PREAMBLE AT HANNAH RIDGE
FILING NO. 3
STREET IMPROVEMENT PLANS
NIGHTWIND HEIGHTS, EQUINE CT./CUL-DE-SAC

PUBLIC EXTENDED DETENTION BASIN GRADING AND OUTLET PROFILE POND 1

V1_Construction Drawings (Plans-Profiles).pdf Markup Summary

4'x4' OUTLET BOX MICRO POOL SECTION A
SCALE 1" = 2"

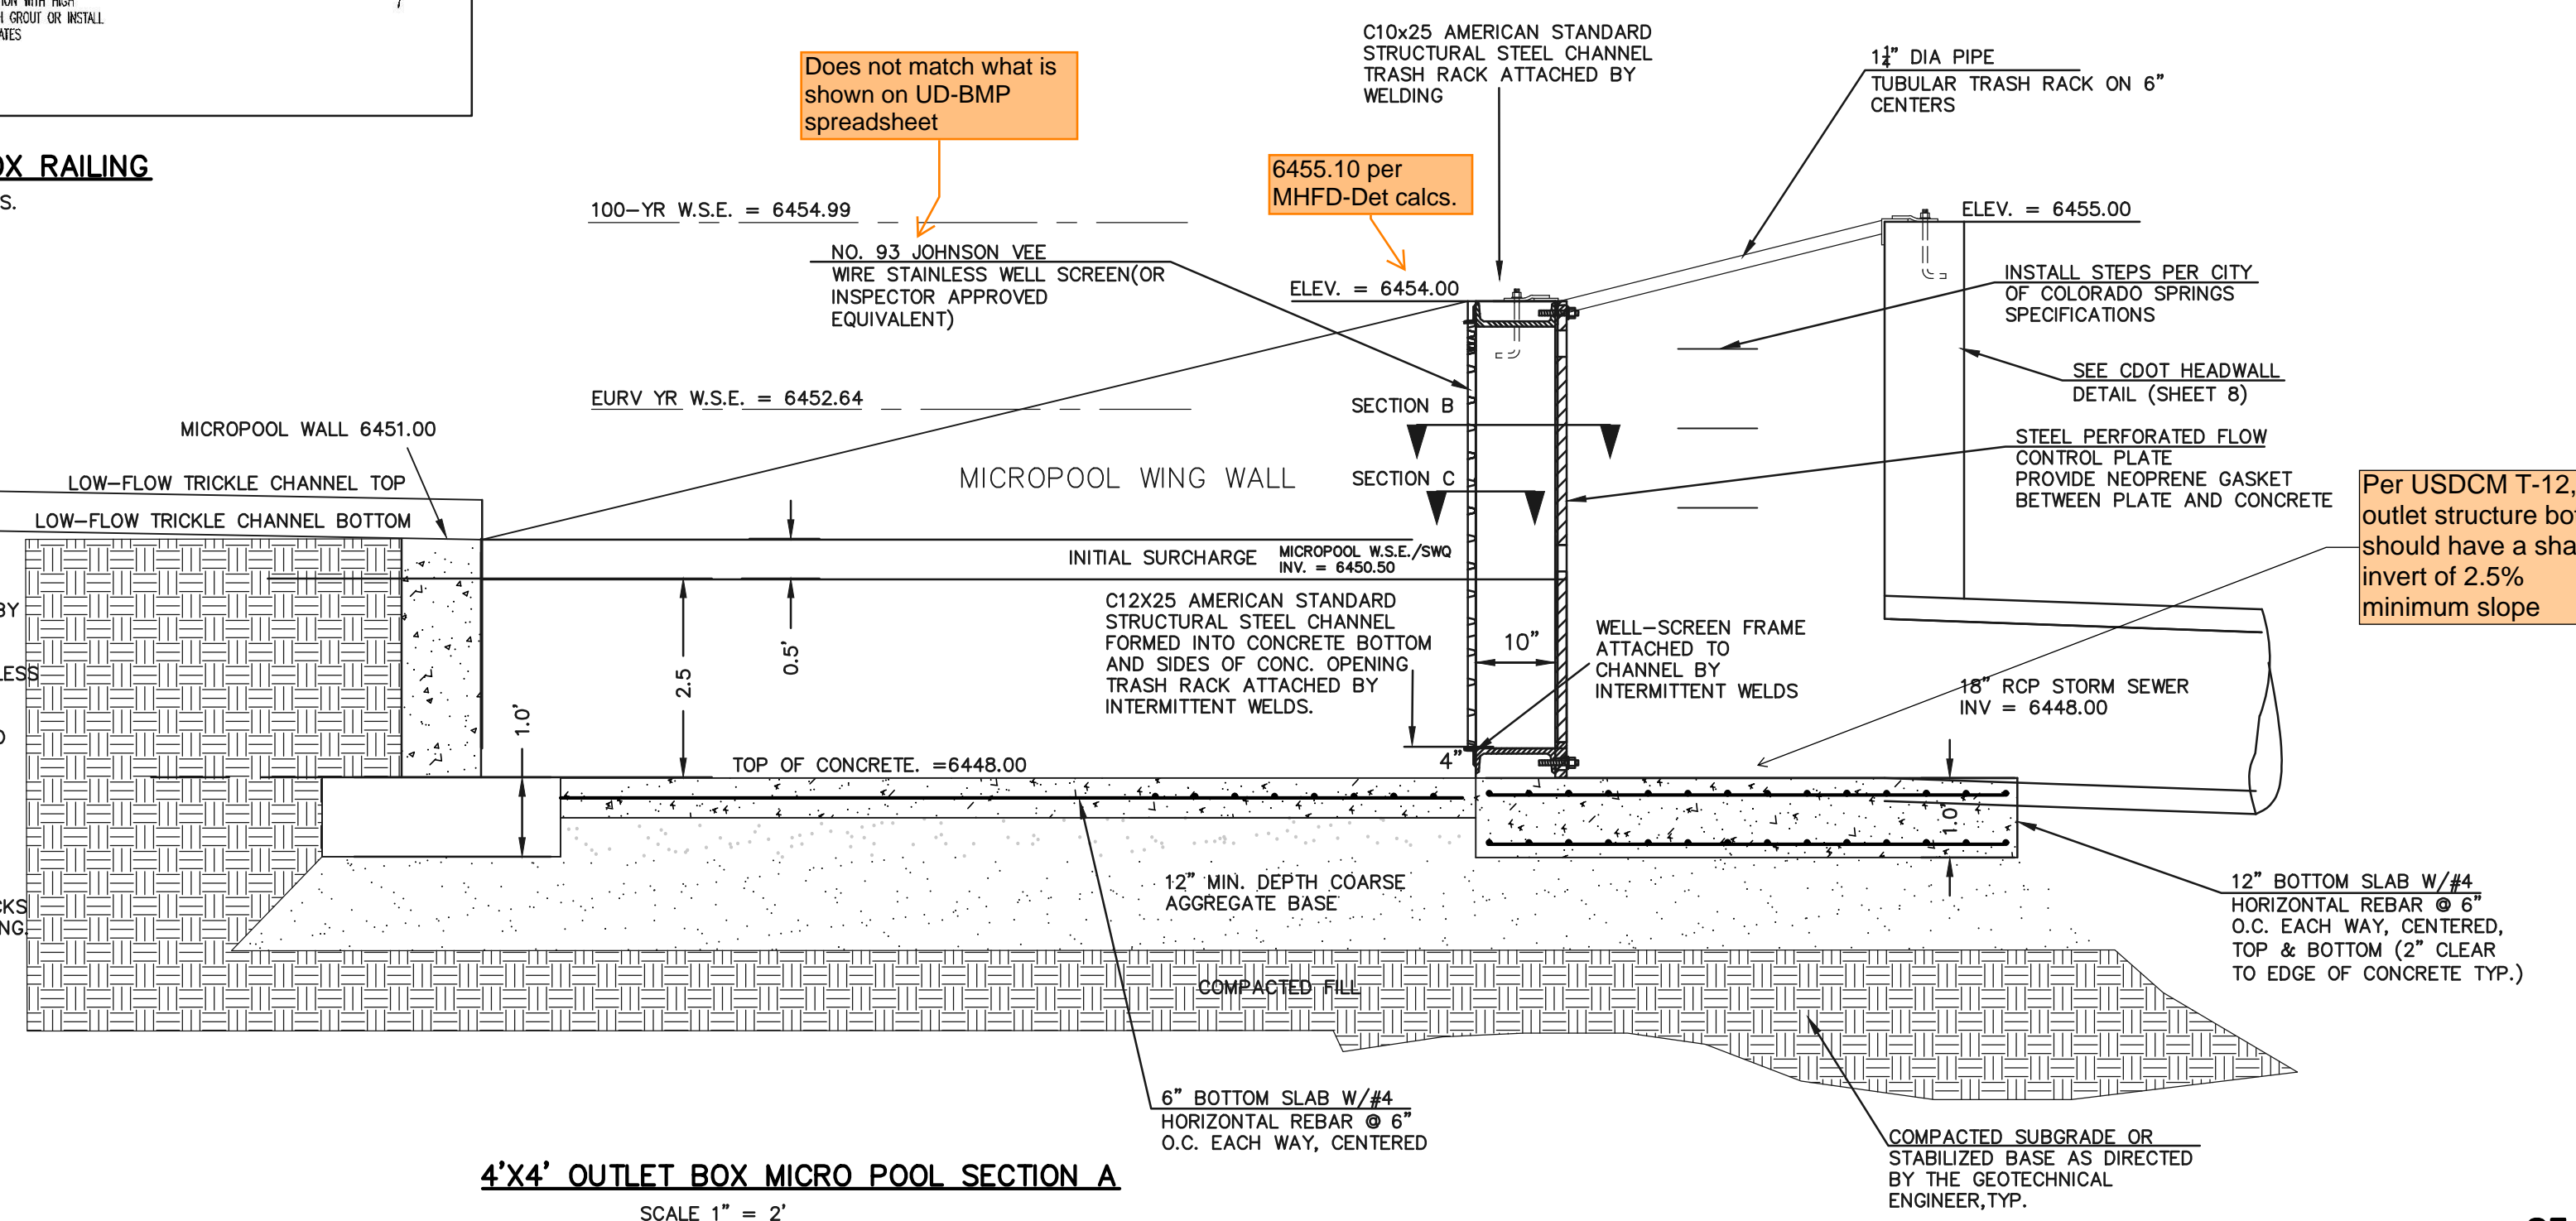
Does not match what is shown on UD-BMP spreadsheet

6455.10 per MHFD-Det calcs.

Per USDCM T-12, the outlet structure bottom should have a shaped invert of 2.5% minimum slope

TRASH SCREEN
SCALE: 1"=1'

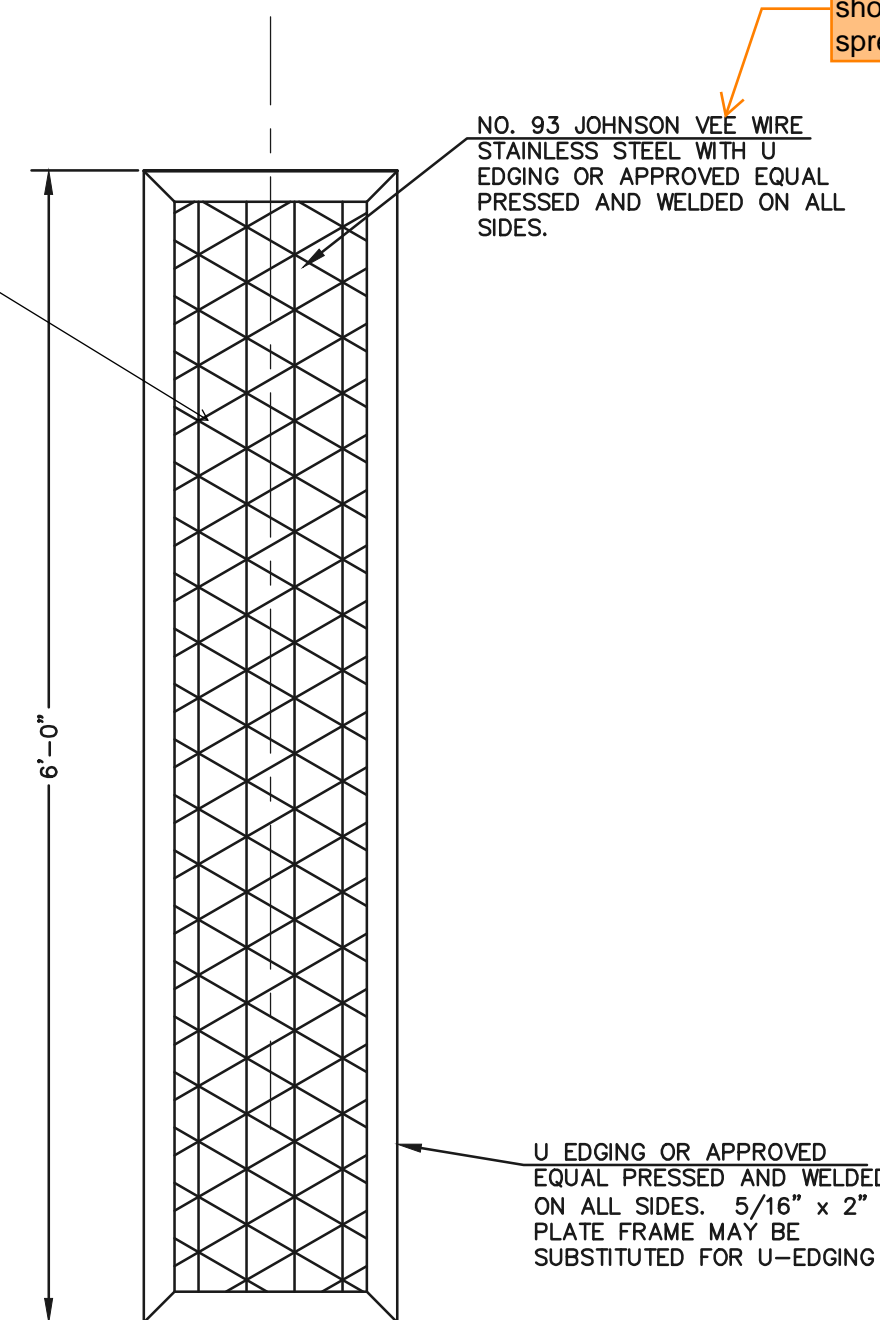
recommend alternative
hatching. Diamond
plate trash racks are
not an equivalent
replacement to those
in our criteria.

Does not match what is
shown on UD-BMP
spreadsheet
